3-22-01
THURS
1 PM ->

SWW MIG @ WLFD

Pond D -

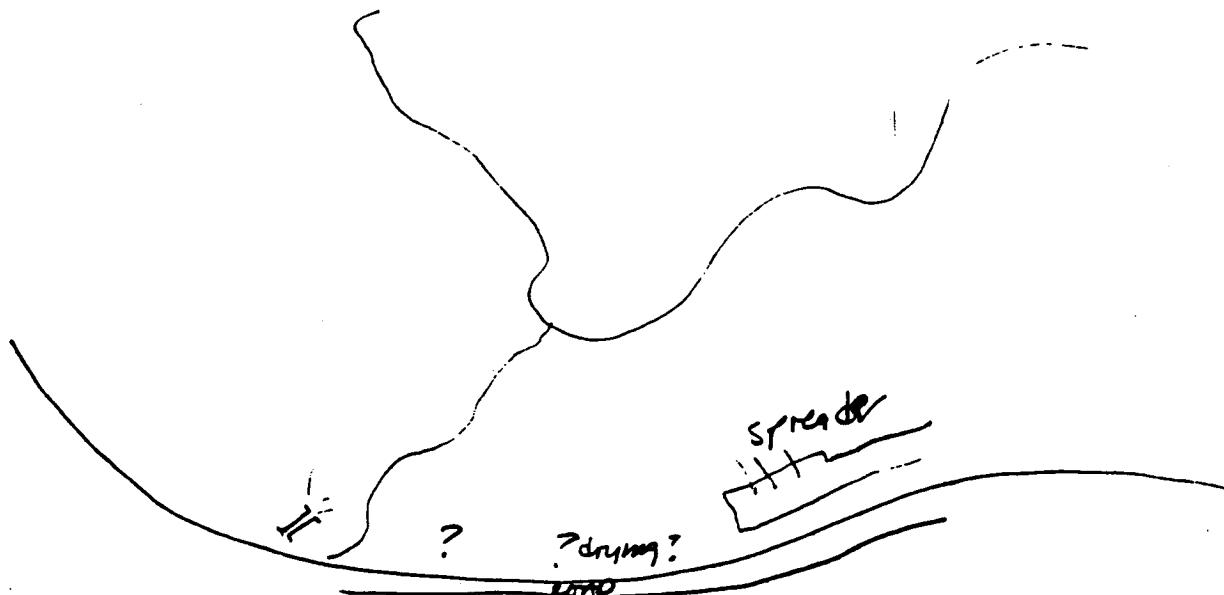
If seasonal ground water max at 336 ft then WL isn't fed by
GW but SW + pond will intercept it + direct it away
from WL. → Pond D will intercept hydrology to WL.
Infiltration facility for 0.2 cfs capacity. No drawings for
facility (Kelly has asked for drawings)
